Quality Control Check Report. Stage: After Finishing Stage III (Apartments)

Quality Control Check Report. Stage: After Brickwork (Apartments)

GULMOHAR RESIDENCY

Details of Additions & Alterations

ELECTRICAL PLAN - 1660 Sft -B2 TYPE

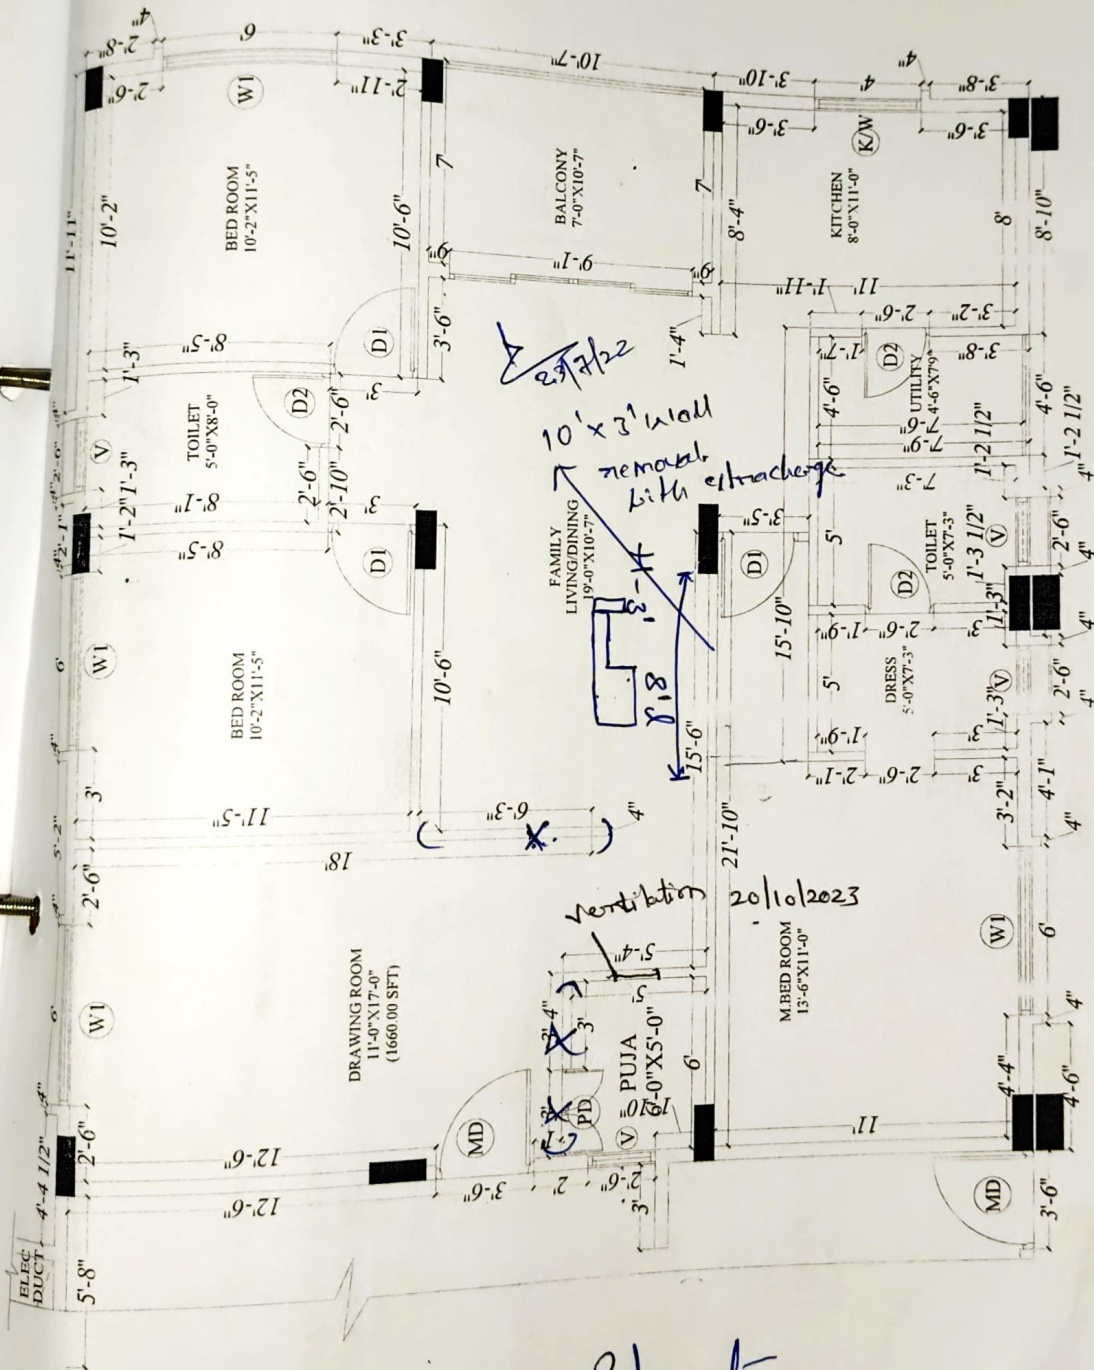
Changes in electrical points: (mark on plan)

① False Ceiling by Customer
